**REDEVELOPMENT OF AN EXISTING DERELICT HOTEL AT TA' KALANKA,
DELIMARA**

ENVIRONMENTAL PLANNING STATEMENT: ADDENDUM

Comments on the 1st draft of the Environmental Planning Statement (EPS)

PA 02767/16 (EA 7/16): Redevelopment of an existing derelict hotel including environmentally friendly measures and provision of public ancillary facilities at Ta' Kalanka, Delimara.

Figure 3.2: Existing Delimara Bay Hotel – General Plan

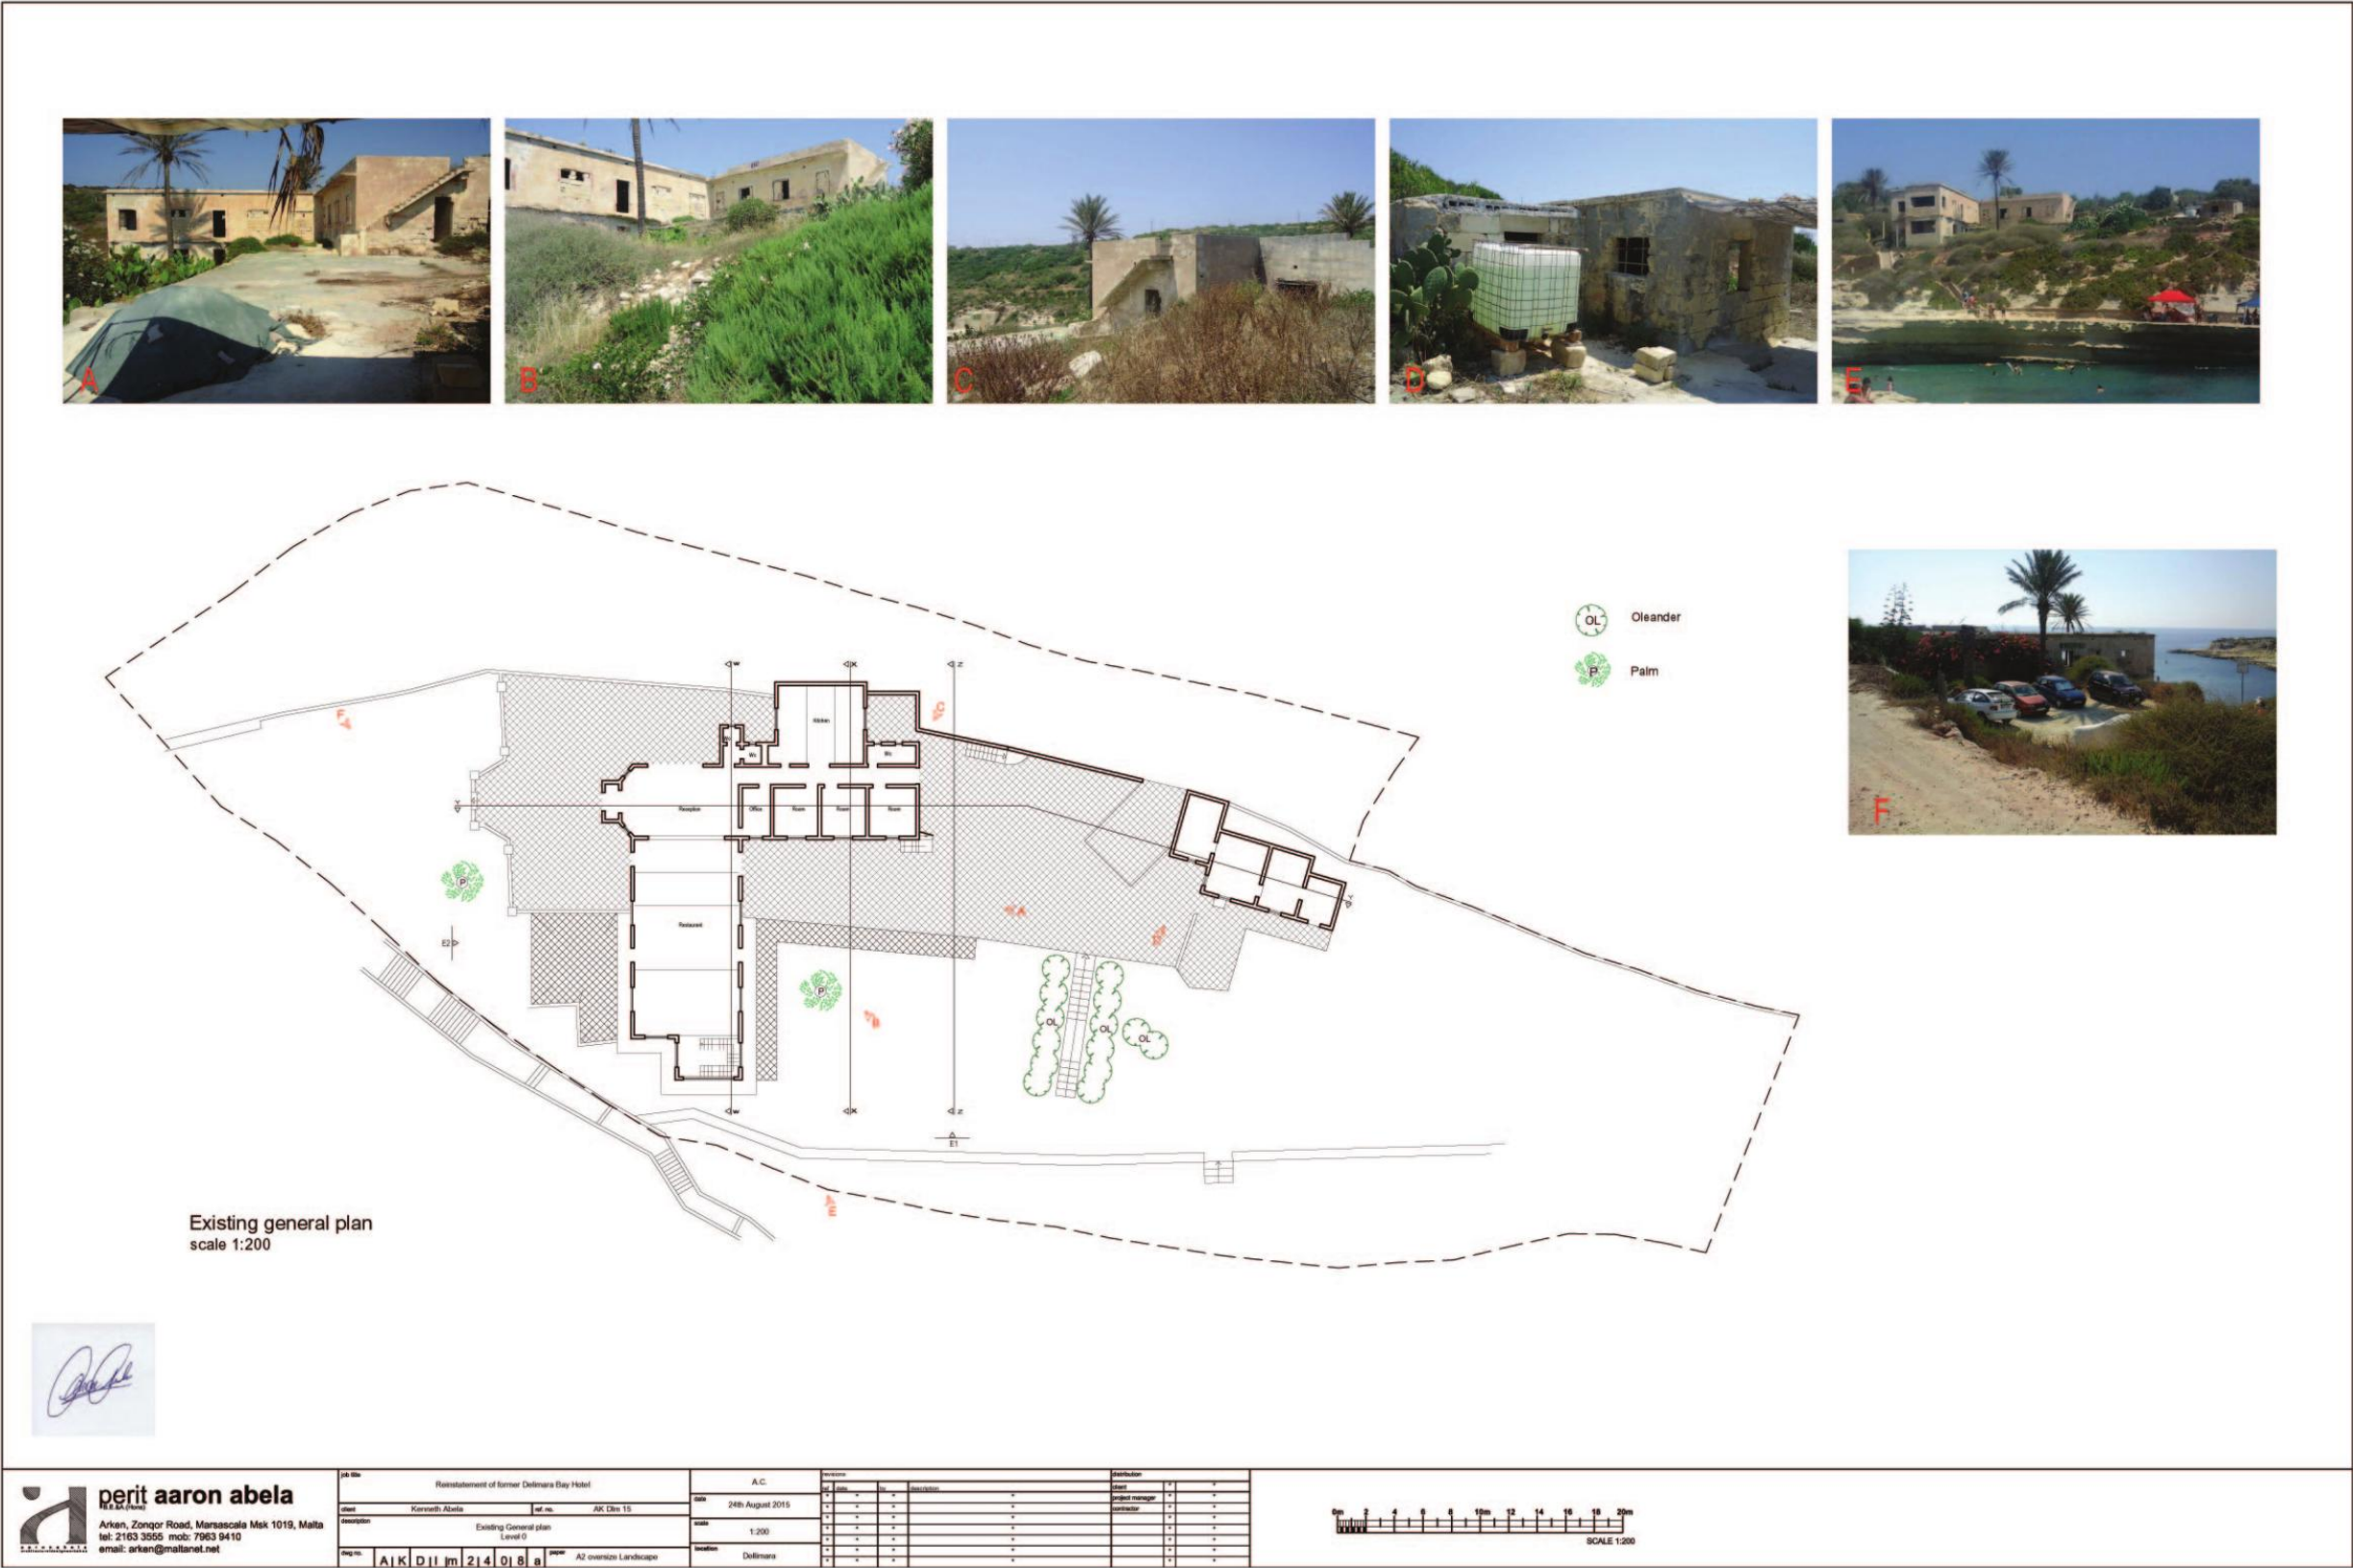
4	18	Figure 3.2	Viewpoint E is included twice.	Noted. Figure has been updated, see Appendix 1 of this Addendum.	Noted. No further comments.	Noted.	-
5	28	3.3 6	ERA is of the opinion that the species, included in the proposed landscaping, are acceptable in terms of development ODZ. However, given that the surrounding area harbours species typical of coastal habitats, the proposed landscaping scheme doesn't sufficiently converge with the surrounding nature and therefore further increases the footprint of the scheme, rather than mitigate it.	Noted. An updated landscaping scheme is included in Appendix 2 of this table.	The updated landscaping scheme is noted and confirmed to converge better with the surrounding area, based on the proposed species composition and massing.	Noted.	-
6	28	3.3 6	Kindly specify the characteristics of the current soil layer in relation to depth requirements of the proposed tree species regarding rooting.	Soil depth was not measured in relation to landscaping. Where soil is too thin, additional material will be added if required in accordance with relevant permits.	Noted. No further comments.	Noted.	-

Figure 3.11: Proposed Site Layout

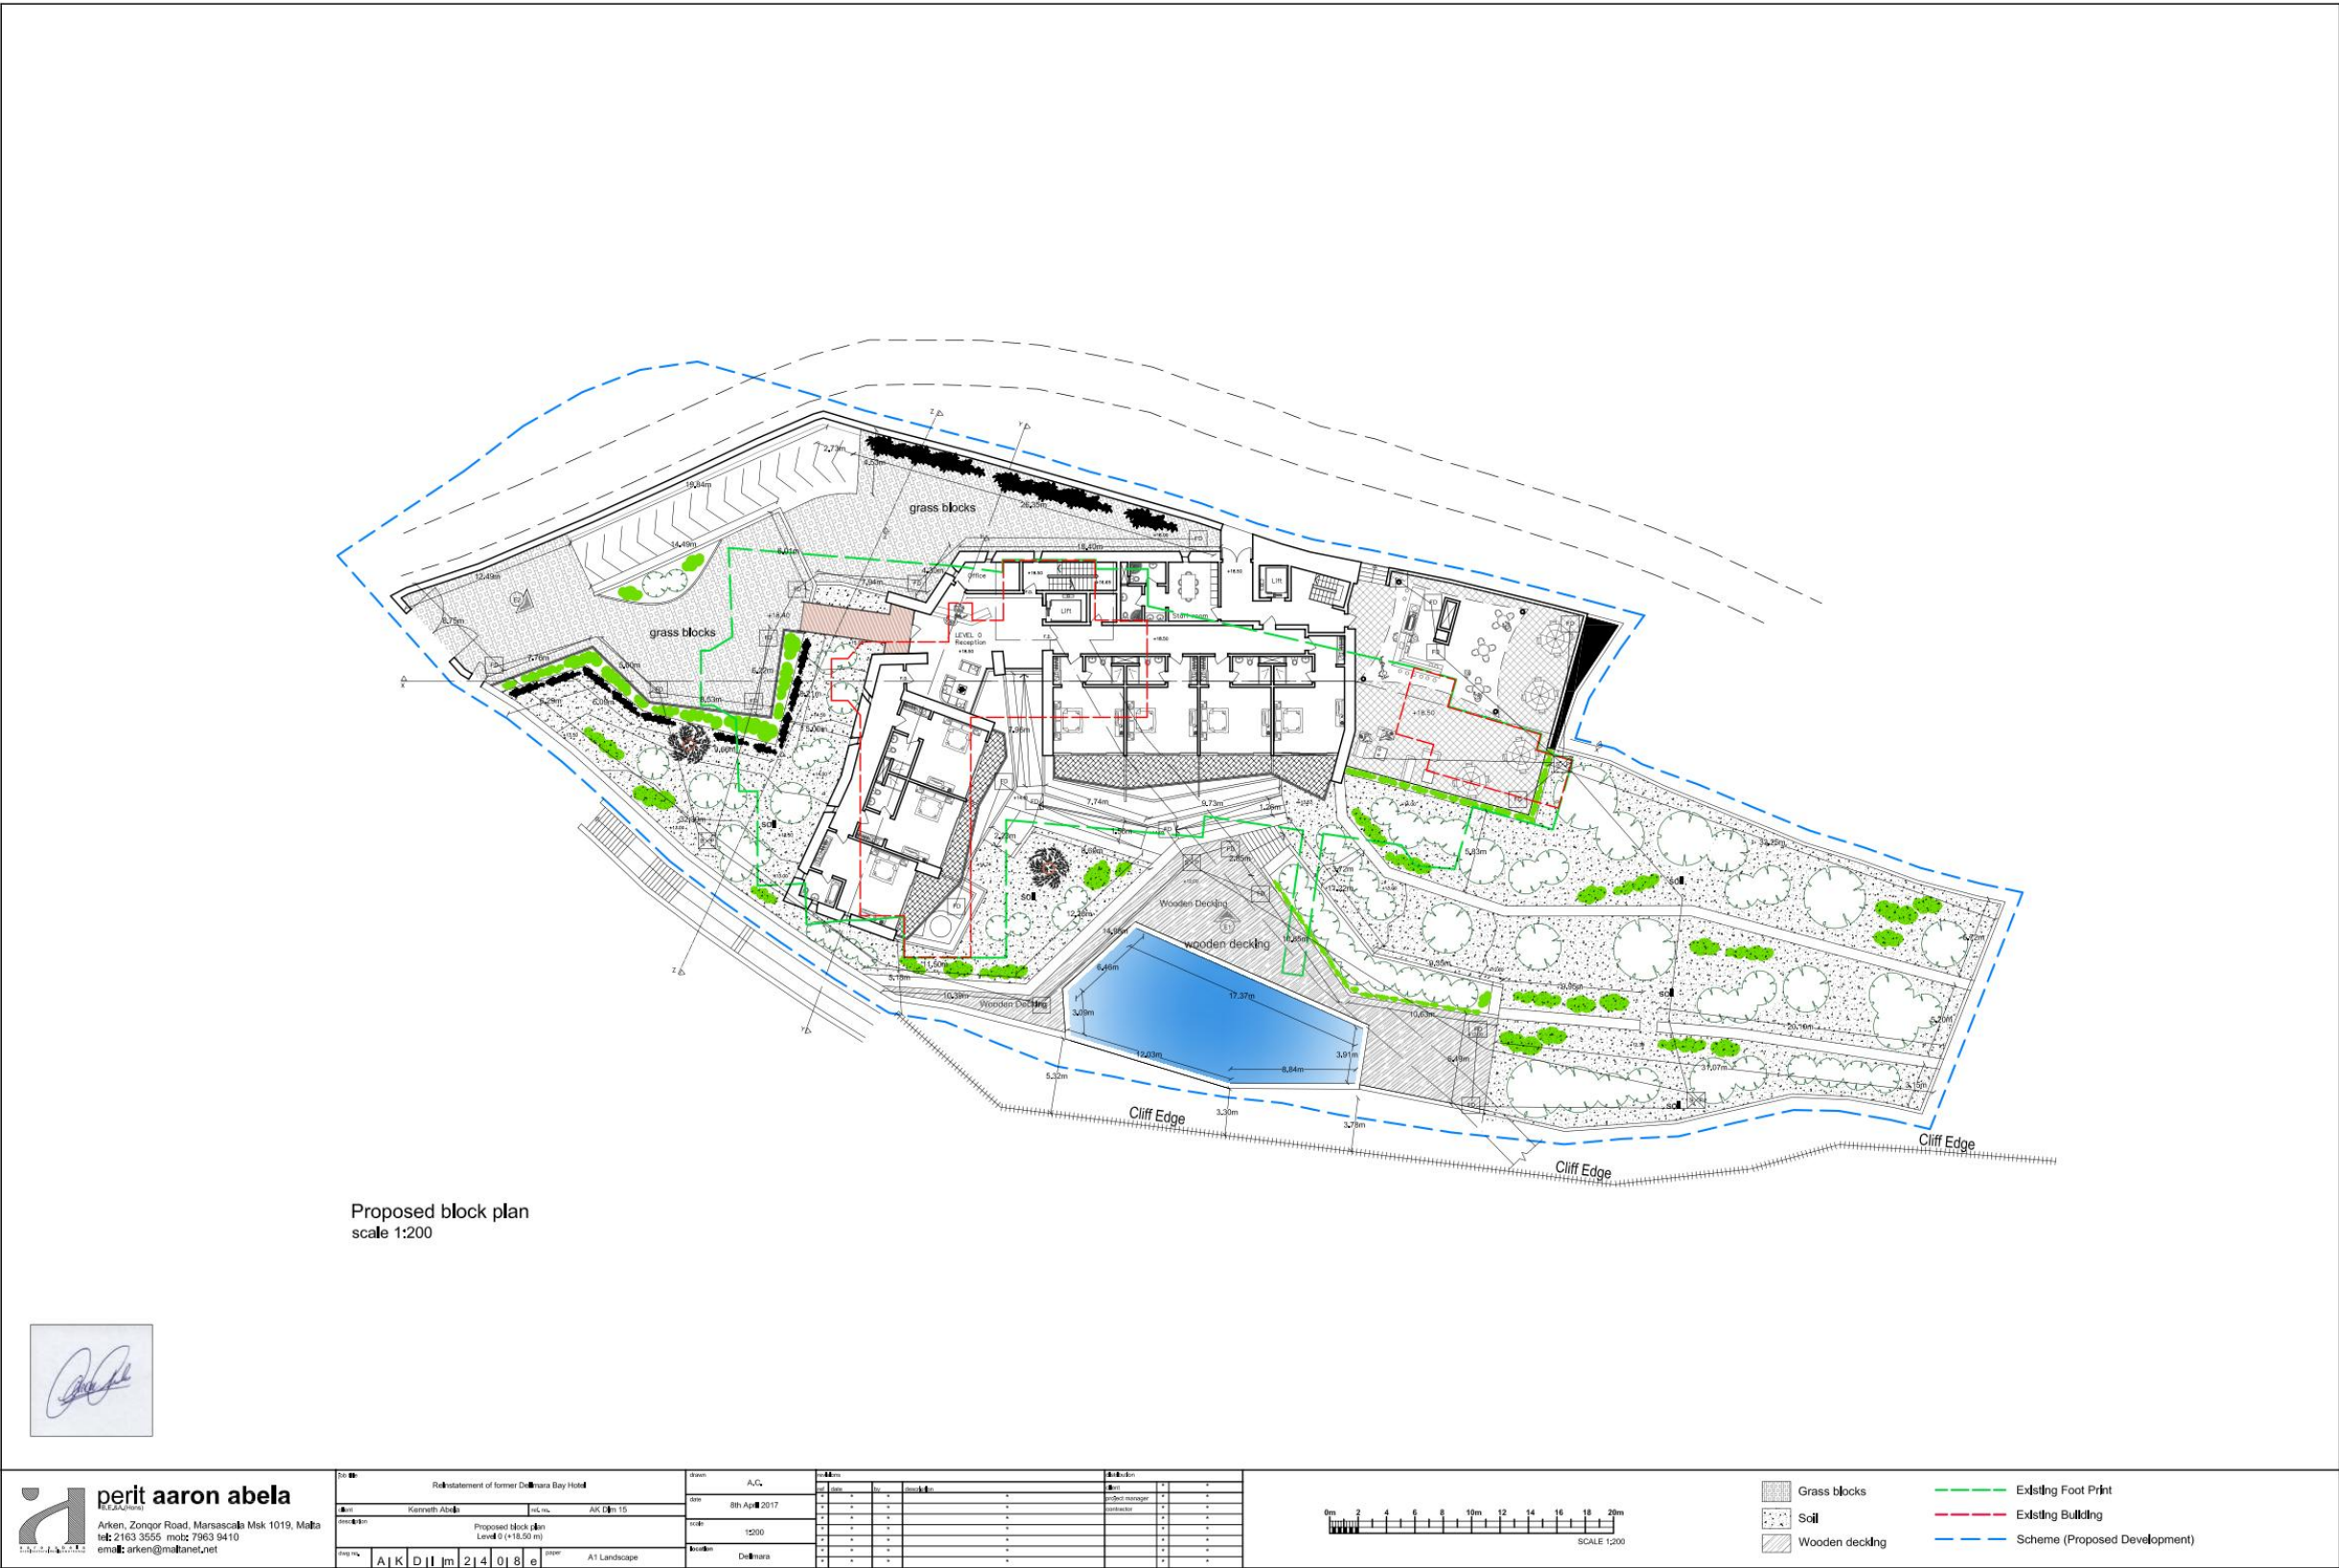
8	28	3.3 7 and Fig ure 3.2 1 (p3 9)	It is stated that lighting will be restricted to the eastern portion of the site. Furthermore, no lighting is to be provided in the landscaped area in the western half of the site. These statements are not according Figure 3.21. Kindly clarify.	All the lighting for the external walking paths are only for floor indication with low power and low luminance.	The use of all lighting for the external walking paths for floor indication is noted. However, kindly revise the reference to the orientation of the lighting in paragraph 3.37. Figure 3.21 shows that lighting will be restricted to the western half of the site, while no lighting is provided in the outer eastern portion of the site.	Paragraph 3.37 to remove sentence: <i>This will be restricted to the eastern portion of the site...</i>	Noted.
9	29-33	Fig ure s 3.1 1 to 3.1 4	For each and every drawing from Figures 3.11 to 3.14, kindly indicate the following keys in the legend: - Existing foot print; - Existing building; and - Scheme site if shown on the plans, for ease of reference.	Plans have been updated, see Appendix 1 to this report.	Noted. No further comments.	Noted.	-
